**TSG-RAN Meeting #9
Hawaii, US, 20 - 22 September 2000**

Title: Agreed CRs to TS 25.435

Source: TSG-RAN WG3

Enhancement to 25.435 to support FDD mode DSCH scheduling from the DRNC

Figure 11: DSCH TFCI Signalling

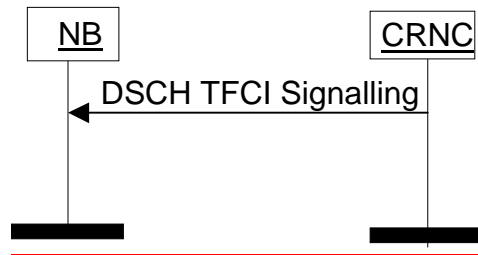
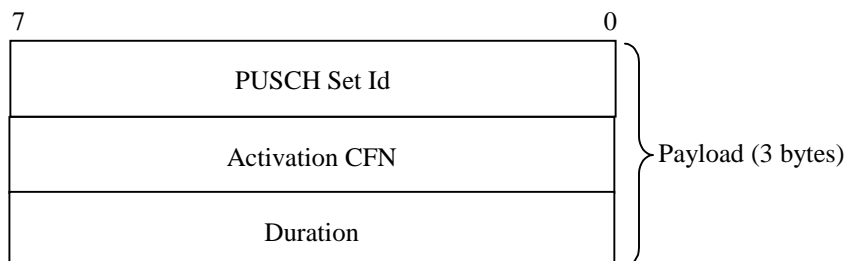
5.6 DSCH TFCI Signalling [FDD]

This procedure is used in order to signal to the node B the TFCI (field 2). This allows the node B to build the TFCI word(s) which have to be transmitted on the DPCCCH.

The procedure consists in sending the DSCH TFCI signalling control frame from the CRNC to the node B. The frame contains the TFCI (field 2) and the correspondent Connection Frame Number. The DSCH TFCI signalling frame is sent once every Uu frame interval (10 ms) for as long as there is DSCH data for that UE to be transmitted in the associated

PDSCH Uu frame. In the event that the node B does not receive a DSCH TFCI signalling control frame then the node B shall infer that no DSCH data is to be transmitted to the UE on the associated PDSCH Uu frame and will build the TFCI word(s) accordingly.

Figure 11: [FDD - Structure of the payload for the DSCH TFCI signalling control frame]

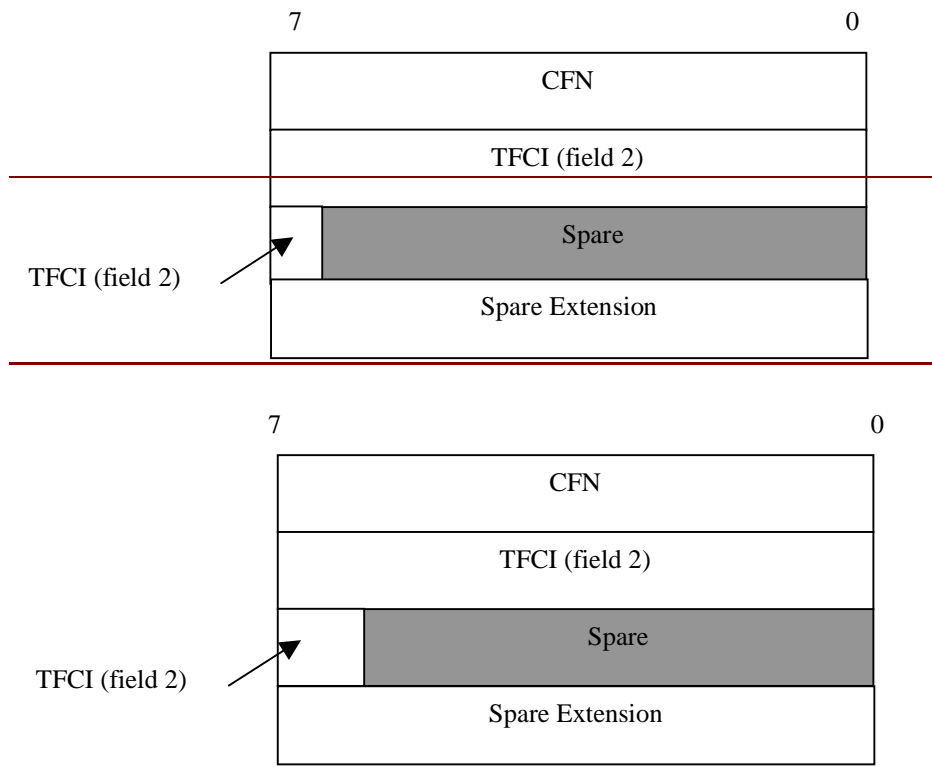
The figure below shows the structure of the payload when the control frame is used for signalling TFCI (field 2) bits. The TFCI (field 2) bits are used by the node B to create the TFCI word(s) for transmission on the DPCCH.

6.3.3.7.2 TFCI (field 2)

Description: TFCI (field 2) is as described in [6], it takes the same values as the TFCI (field 2) which is transmitted over the Uu interface.

Value range: {0 - 1023}

Field length: 10 bits

Figure 17: FDD DSCH Data Frame structure

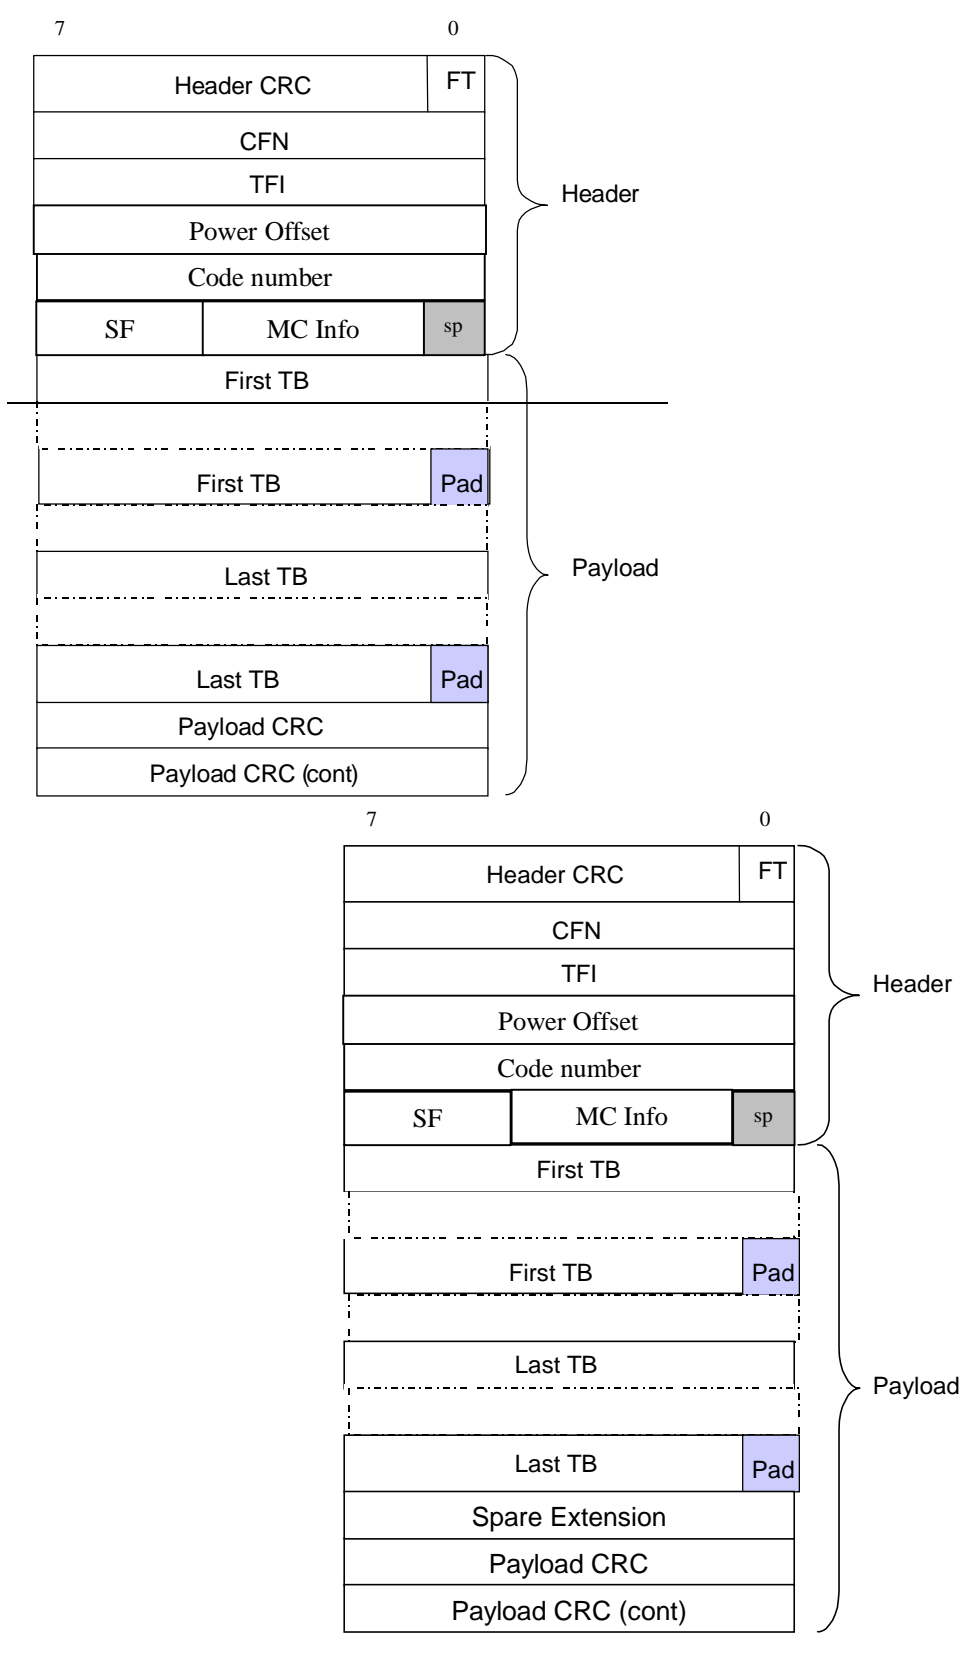
Reason for change: Added spare extension octets to DSCH Data Frames.

Clauses affected: 6.2.5 (figures 17 and 18)

Figure x: Timing Advance Signalling

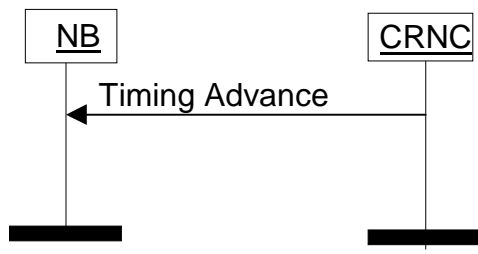
5.x Timing Advance [TDD]

This procedure is used in order to signal to the node B the adjustment to be performed by the UE in the uplink timing.

The Node B shall use the CFN and timing adjustment values to adjust its layer 1 to allow for accurate impulse averaging.

Figure x: Structure of the Timing Advance control frame

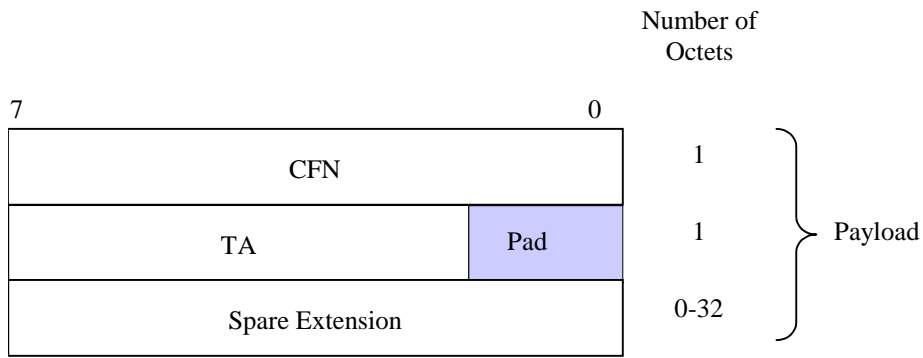
Figure below shows the structure of the payload when the control frame is used for timing advance.

6.3.3.x.2 CFN

The CFN value in the control frame is the frame that the timing advance will occur and is coded as in subclause 6.2.6.3.

6.3.3.x.3 TA

Description: UE applied UL timing advance adjustment.

Value range: : 0-252 chips, and the resolution is 4 chips.

Field length: 6 bits.
